Job Address	LOT	SQUARE	Building Permit	SWM Plan #
4509 Foxhall Crescent NW	960	1397	--	7400

Date: 6/15/2022

The existing lot is a vacant wooded lot. The project proposes a new detached single-family dwelling with a permeable pavement driveway. There are existing special trees and were existing heritage and special trees that were removed without permits. The project is a Major Land Disturbing project and must retain the 1.2” storm. The site is in the MS4. Green area ratio (GAR) is not required.

Sheet CIV130

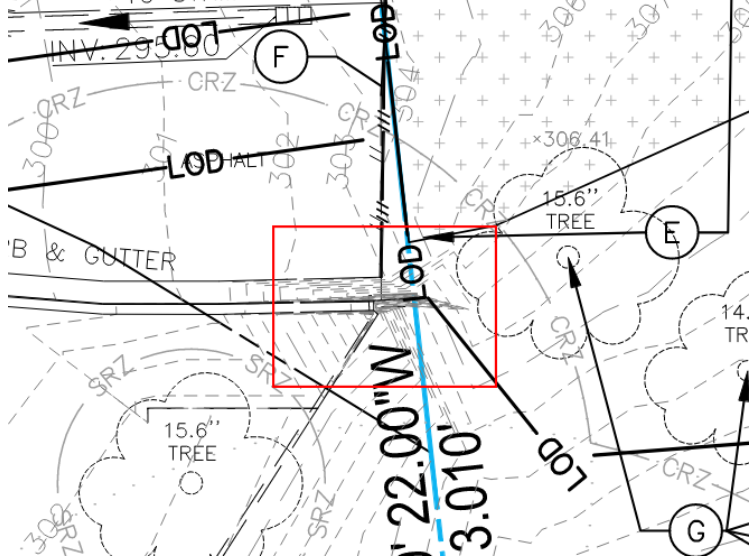
- 9) Provide an ESC plan for the demolition work.
- 10) Trees with a circumference of 100 inches (31.8 inches in diameter) or greater are Heritage Trees and cannot be topped, cut down, removed, girdled, broken, or destroyed. Refer to the Tree Canopy Protection Amendment Act of 2016 for more information. Based on these plans a heritage tree has been removed. Contact the Ward 3 DC arborist, Yasha Magarik (yasha.magarik@dc.gov). Additionally, there is work proposed within existing heritage trees to remain. Provide the approved tree protection plans.
- 11) There are special trees proposed to be removed and previously removed without permit.

To remove trees with a circumference greater than 44 inches (14 inches in diameter), a Special Tree Removal Permit is required from the DDOT Urban Forestry Division. Provide the DDOT tree removal permit number.

- 12) Show the extent of excavation on the demolition plan.
- 13) What is occurring in the red box shown below? It appears there may be wall there based on imagery however the contour lines are misleading. Clarify.
